ENGINE - INTRODUCE RECONTOURED STAGE 1 AND 2 TURBINE ROTOR HUBS - CATEGORY CODE 8 -
MOD.ENG-72-0075

V2500-ENG-72-0075

Location of stage 1 Turbine Hub Assembly
Fig.1

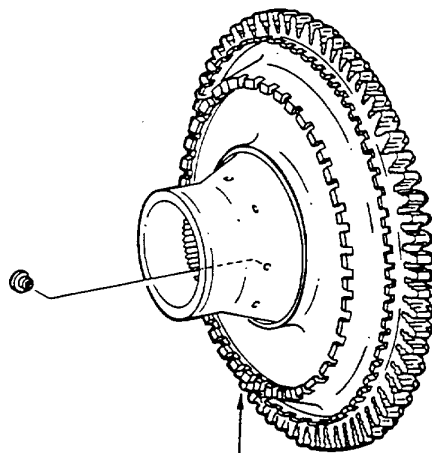
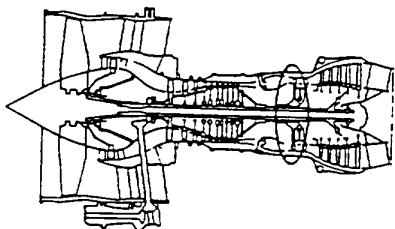
- (a) Assemble the Stage 1 Turbine Rotor Assembly by the approved procedure in Reference (3), Chapter/Section 72-45-10, Assembly. See Figure 1.
- 1 Use 2A2221 Stage 1 Turbine Hub Assembly (1 off).

INSTALL PN 2A2221
STAGE 1 TURBINE
HUB ASSEMBLY (1 Off)

- 2 Identify the 2A2721 Stage 1 Turbine Rotor Assembly as 2A2121 by the approved procedure in Reference (4), Chapter/Section 70-09-00, Marking of Parts. Mark the new identification adjacent to the old identification. Use the vibration peen method.

Location of stage 2 Turbine Hub Assembly
Fig.2

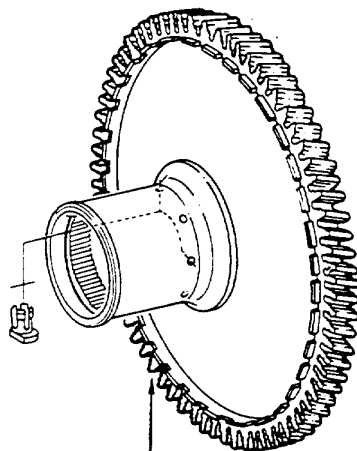
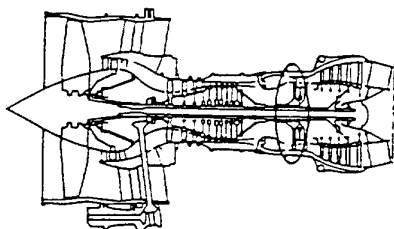
- (b) Assemble the Stage 2 Turbine Rotor Assembly by the approved procedure given in Reference (3), Chapter/Section 72-45-30, Assembly. See Figure 2 and 3.

INSTALL PN 2A1802
STAGE 2 TURBINE HUB
ASSEMBLY (1 Off)

- 1 Use 2A1802 Stage 2 Turbine Hub Assembly (1 off).
- NOTE: 2A1097 Stage 2 HPT Lock and 2A1638 Turbine Blade Lock Retainer must be used with 2A1802 Stage 2 Turbine Hub Assembly.

Location of stage 2 HPT Lock
Fig.3

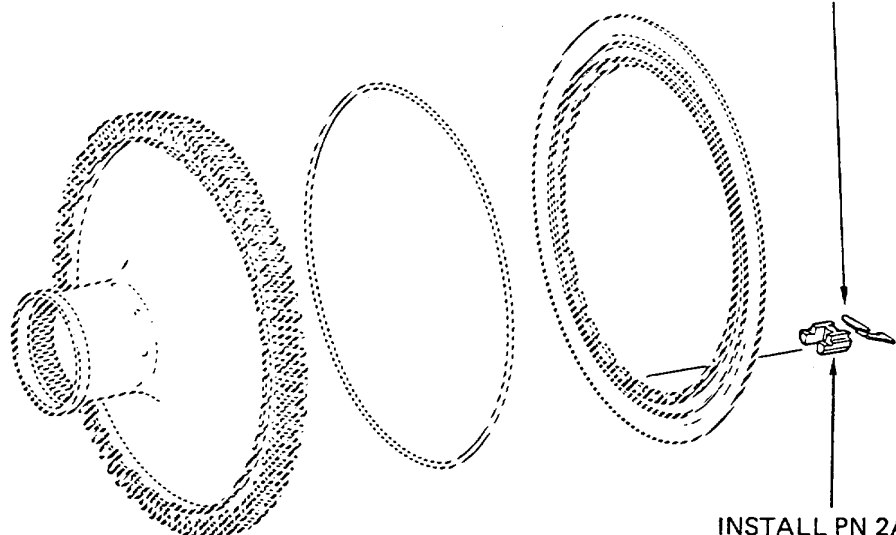
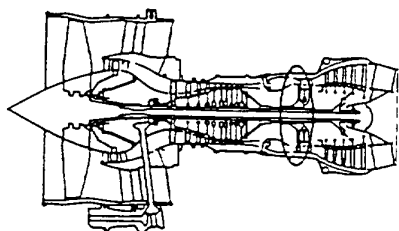
INSTALL PN2A1638
TURBINE BLADE
LOCK RETAINERS
(2 Off)

INSTALL PN 2A1097
STAGE 2 HPT LOCKS (2 Off)

- 2 Use 2A1097 Stage 2 HPT Lock (2 off).
- 3 Use 2A1638 Turbine Blade Lock Retainer (2 off).
- 4 Identify the 2A1022 Stage 2 Turbine Rotor Assembly as 2A1922 by the approved procedure in Reference (4), Chapter/Section 70-09-00, Marking of Parts. Mark the new identification adjacent to the old identification. Use the vibration peen method.
